**Planning and Zoning Commission
January 6, 2022
Council Chambers
6:00 PM**

Subject: Petition No. 2021 -01 (ALU) CDP Amendment - Maitland Concourse North (MCN)
Requested Action or Motion: After receiving public comments, forward the proposed CDP Amendment, Petition No. 2021-01 (ALU), to remove the prohibition of drive-thru uses on Lot 1, MCN to Council with a recommendation of approval.
Summary Explanation & Background: The Maitland Concourse North (MCN) CDP Amendment was adopted in 2013 via Ordinance 1236. This established a Policy and Standards to guide the MCN mixed use development program on the roughly 96 gross acre site on the north side of Maitland Boulevard. The CDP standards were designed to regulate items such as appearance (residential scale and character); buffering, size (no big box); floor area ratio, height, and uses (including use prohibitions). Among the uses prohibited within the (R-MORC) commercial portion of the site were, <i>drive-through establishments of any kind</i>. The R-MORC commercial portion of the site covered Lots 1,2,3,6 and a portion of Lots 4 (stormwater pond) and 7 (developed with 350 multi-family units) . The CDP amendment proposes to remove the

MAITLAND CONCOURSE NORTH	SHEET NUMBER PD3.2	CITY OF MAITLAND FLORIDA	SITE PLAN SE	LICENSED PROFESSIONAL JONATHAN A. MARTIN, P.E. FLORIDA LICENSE NUMBER 54055	REVISIONS No. DATE	BY

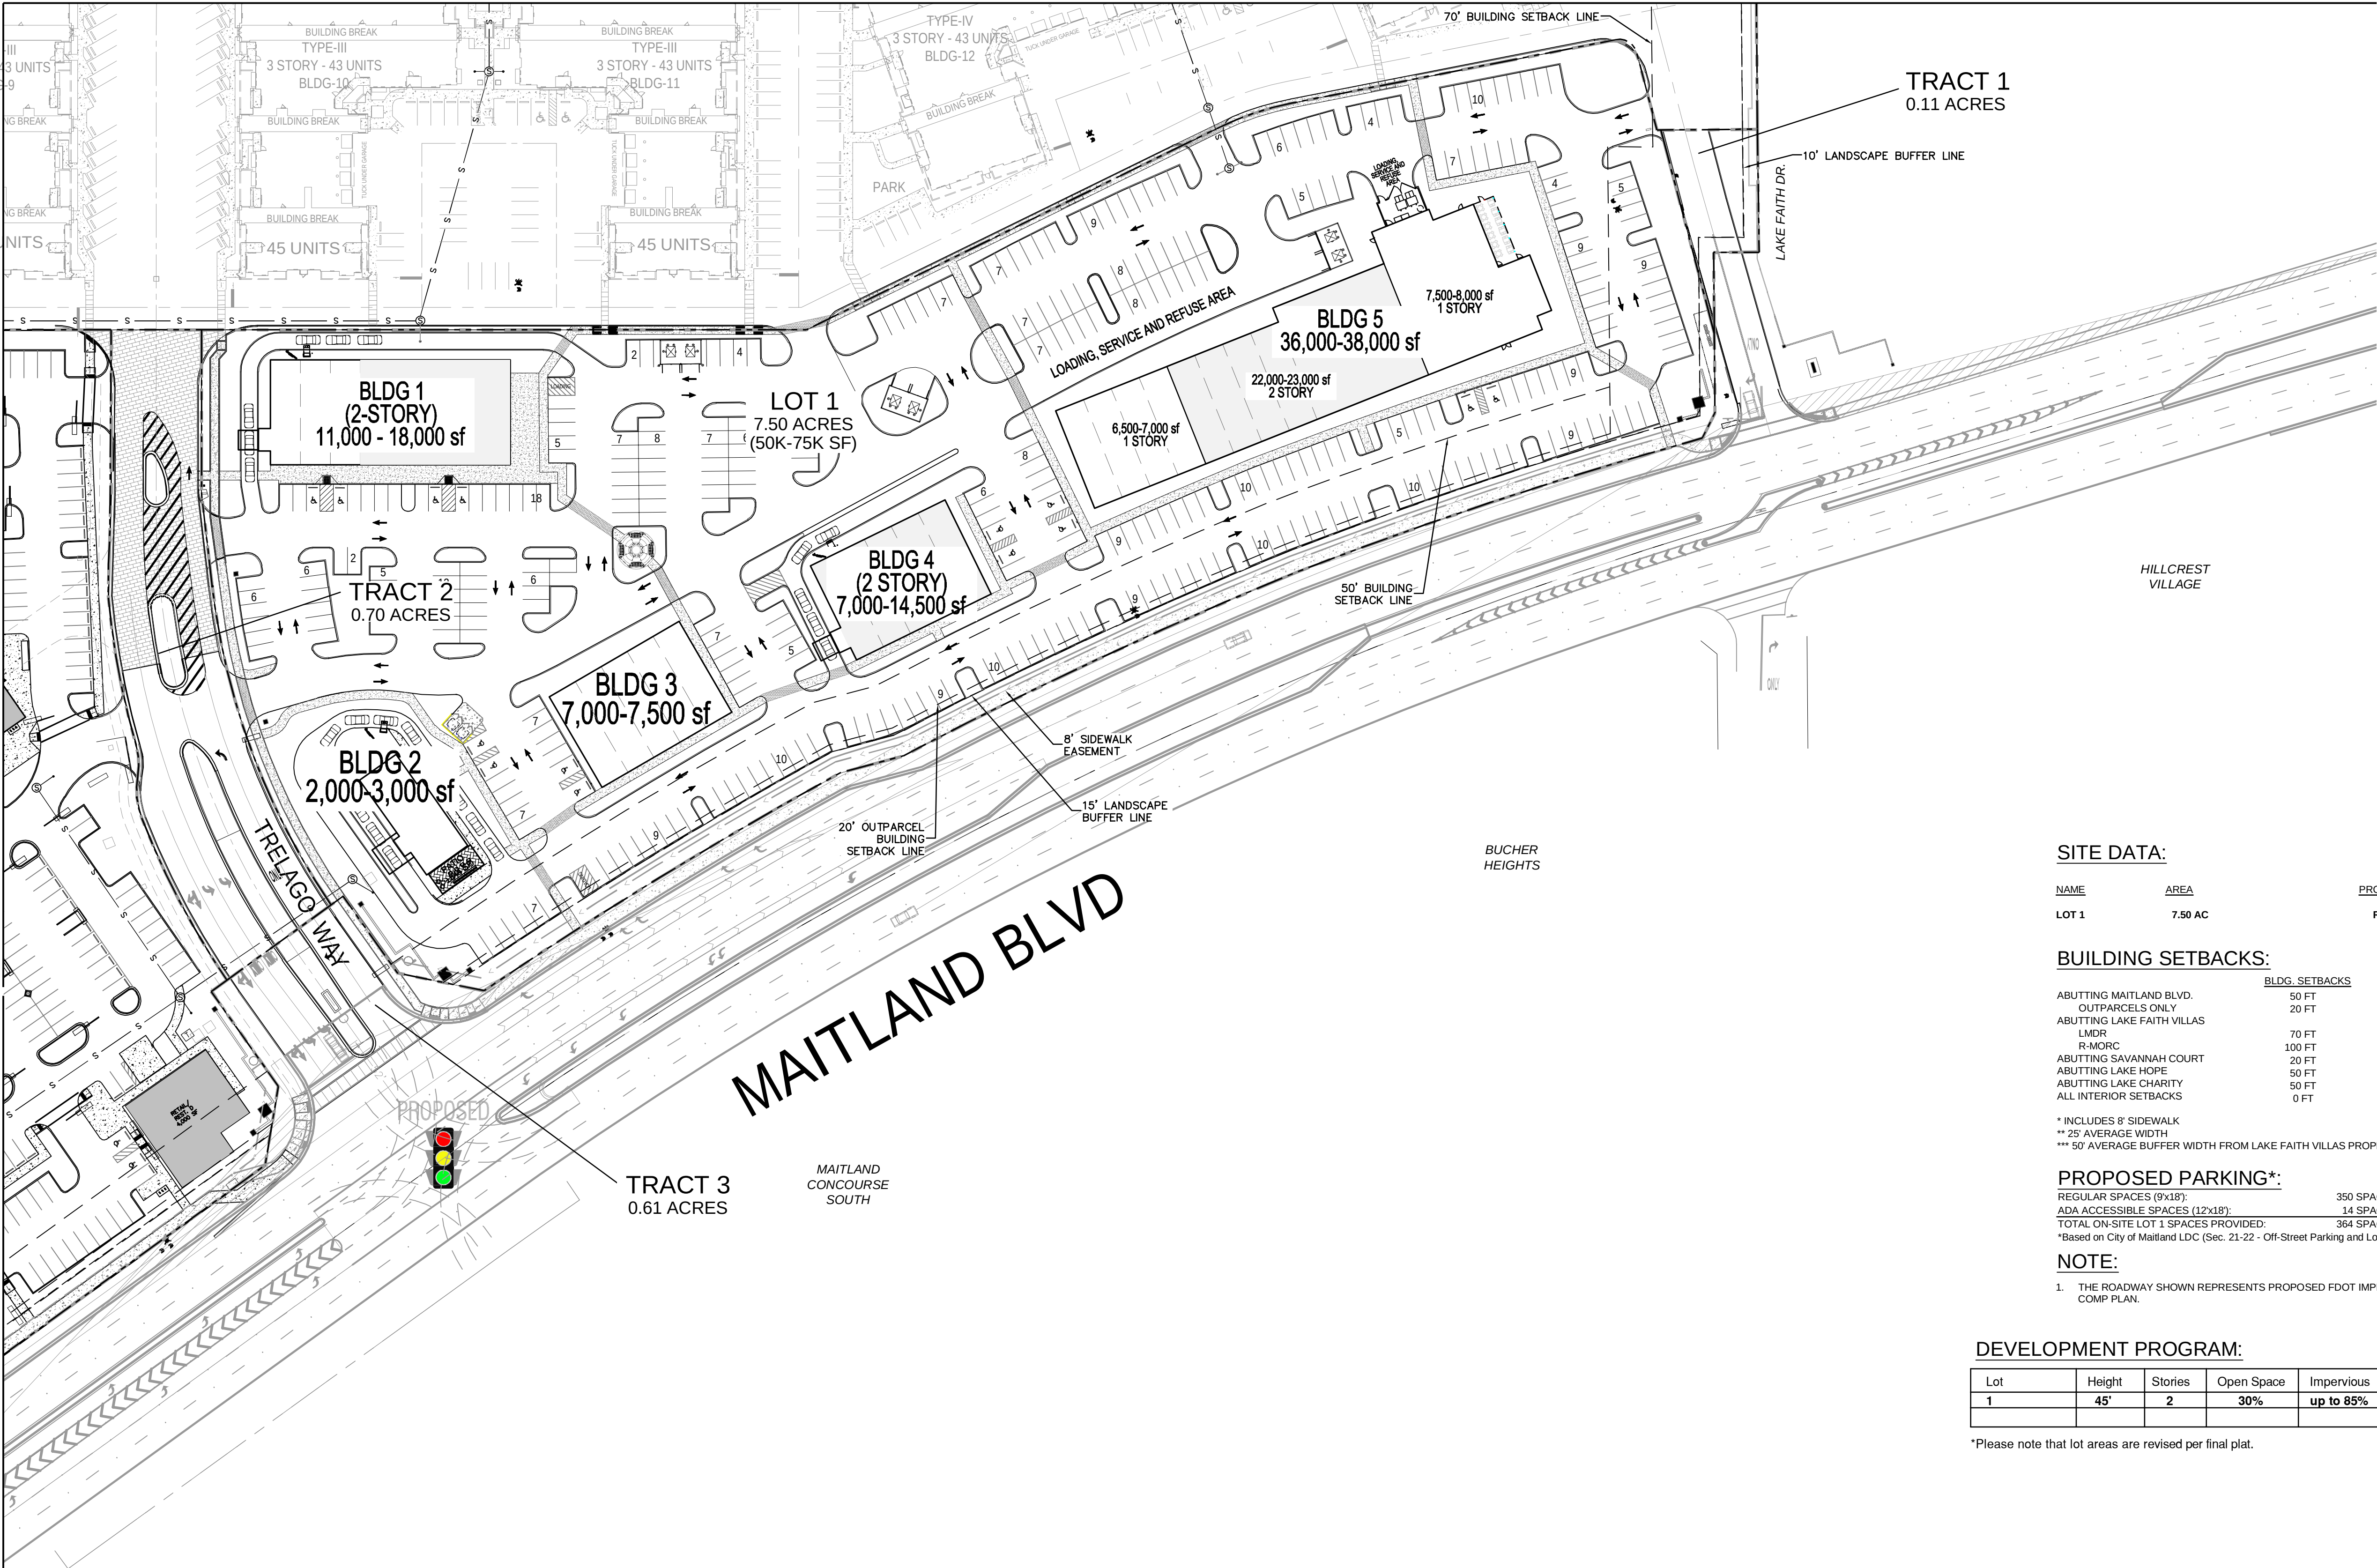
2. Supplemental information.
 2. Site plan drawn to a noted scale and to include:
 - f. Please provide number of off-street parking spaces and stall dimensions

- h. Please provide location and number of loading areas, service and refuse areas;

- l. Please provide arrows to demonstrate internal traffic circulation patterns;

- a. The table showing density should be corrected or removed as it appears that dwelling units are being added. Please address.

Response: This is shown on sheet PD3.2

Response: This is shown on sheet PD3.2.

Response: Traffic circulation arrows have been added to sheet PD3.2.

Response: This table has been removed from sheet PD3.2.

LANDSCAPE PLAN SE

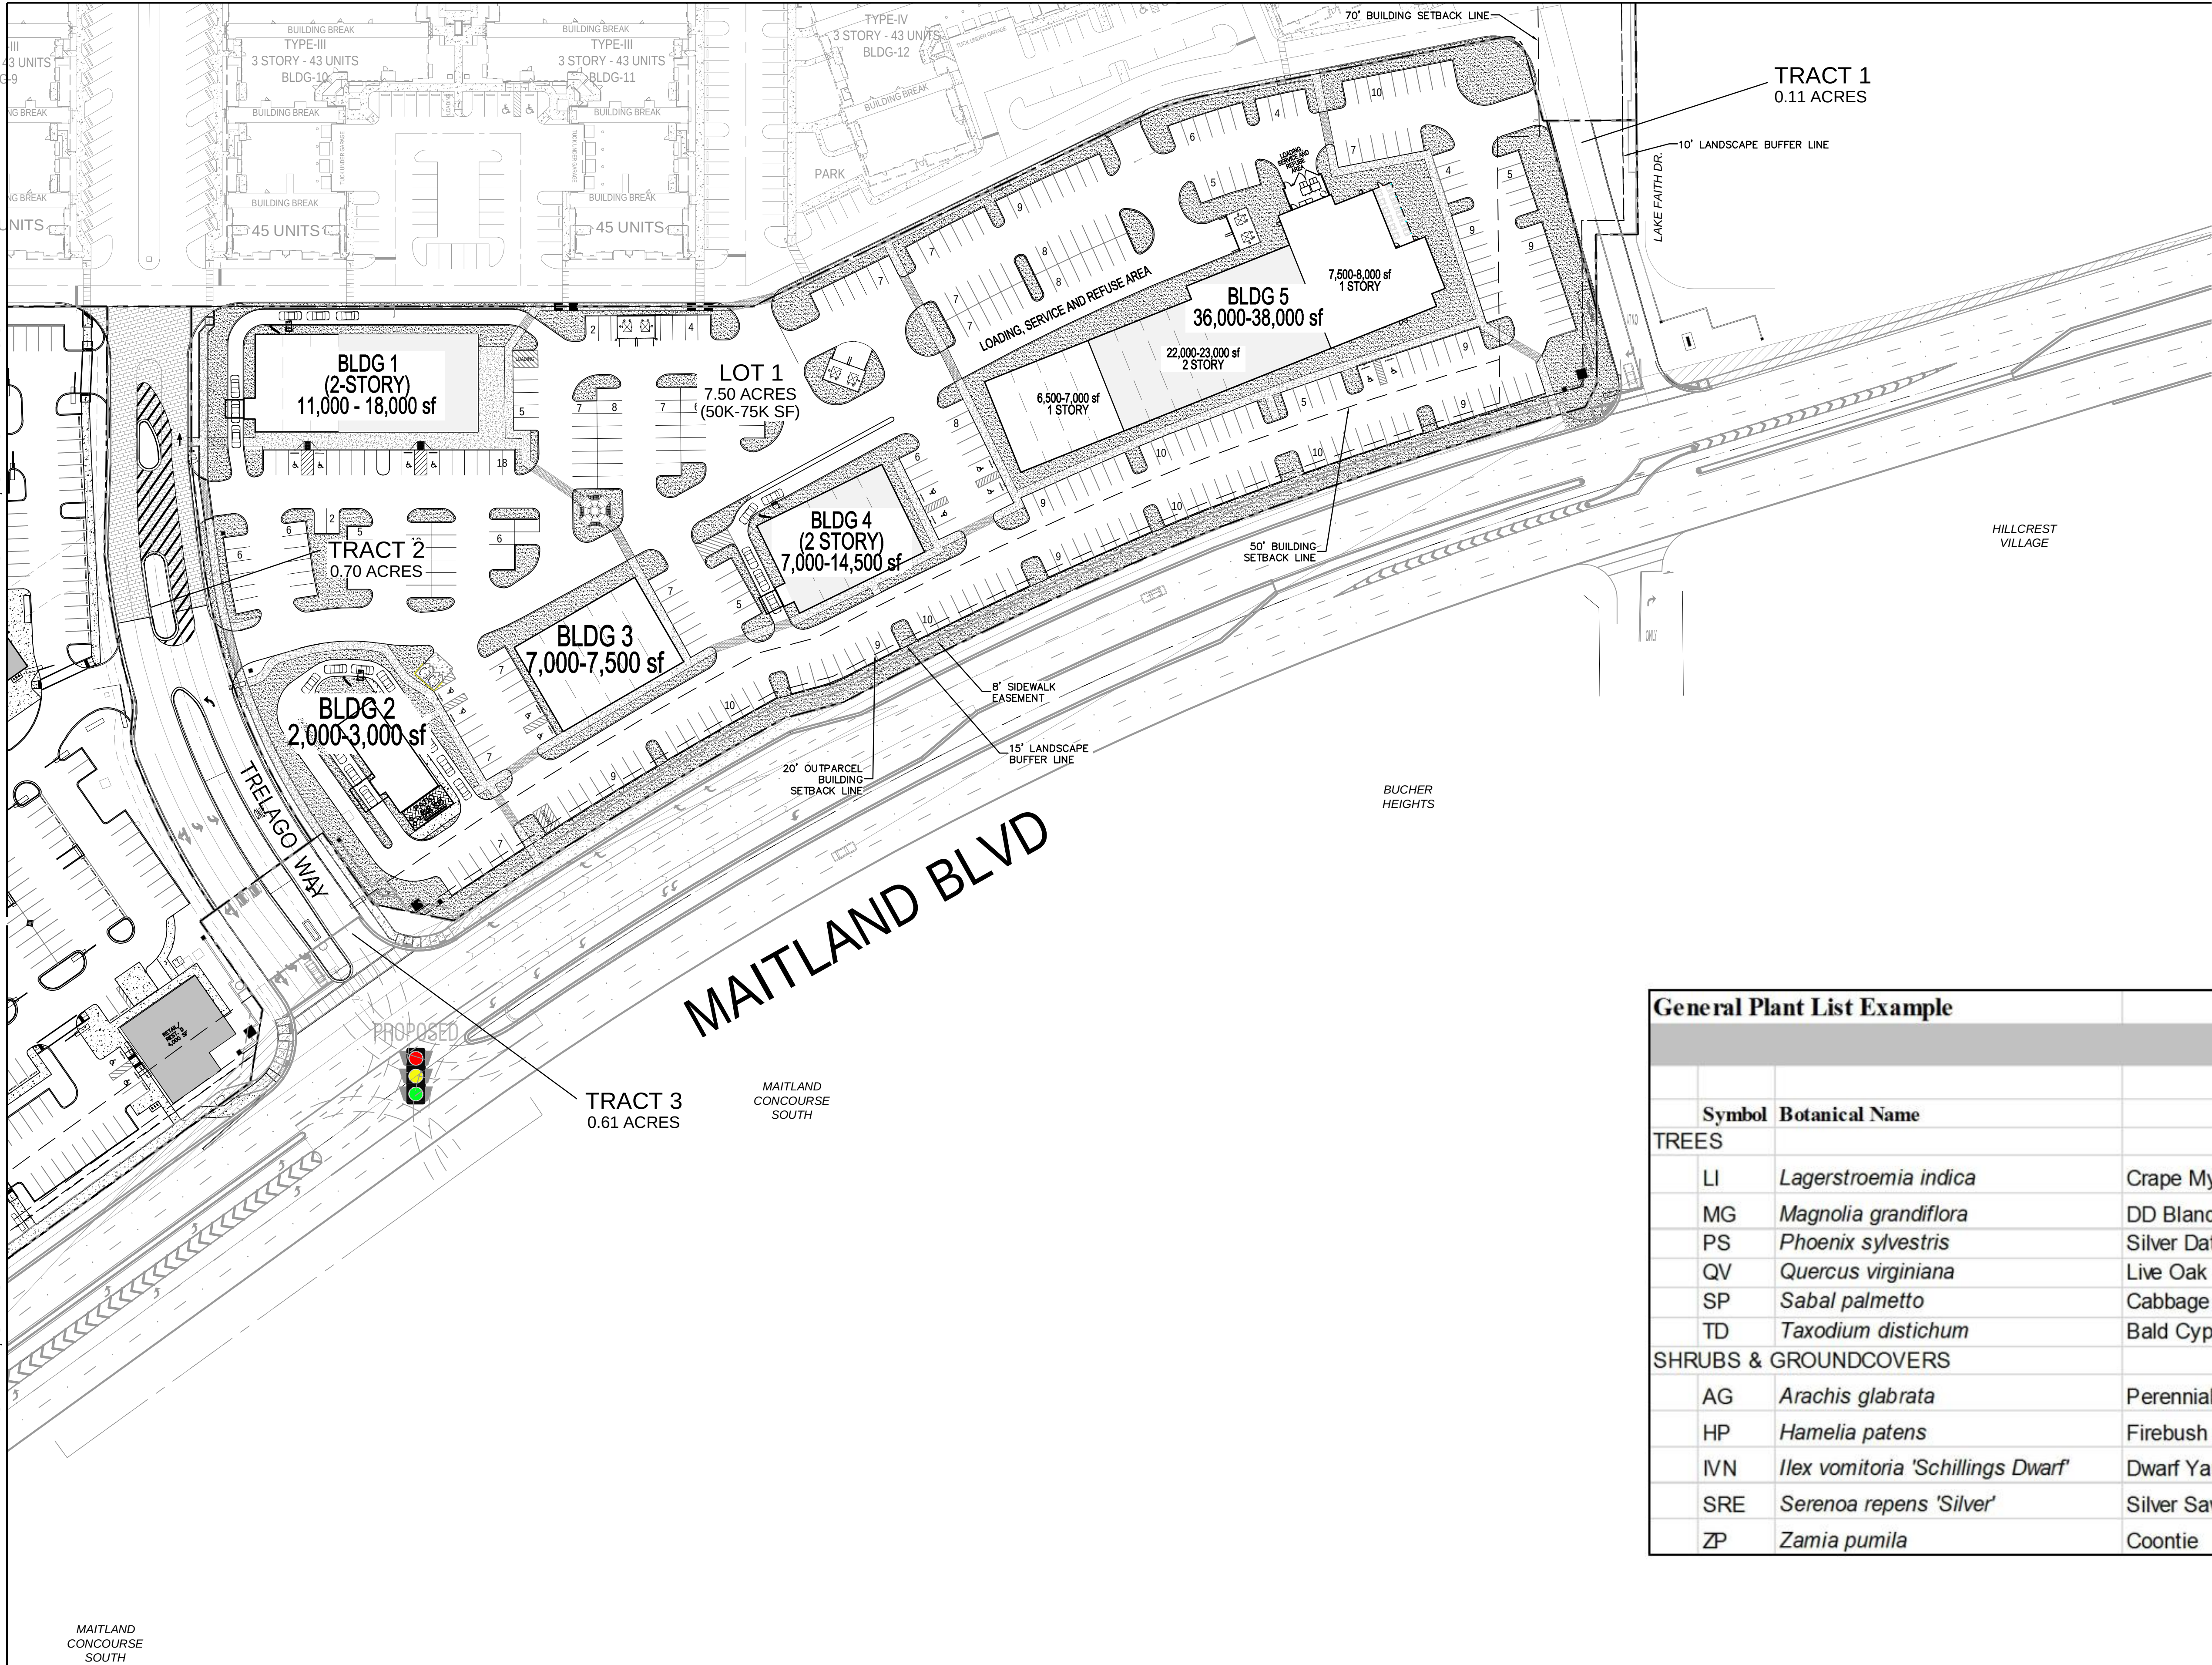
6. Schematic Landscape Plan showing:
 - a. Proposed landscape areas, screening and buffers (reference general plant list, buffer types and canopy points.

Response: The landscape screening and buffers are as approved in the original PD. Sheet L1.01 is included in this submittal for reference as well as an enlarged area showing a hatch for the landscaped areas for the proposed layout.
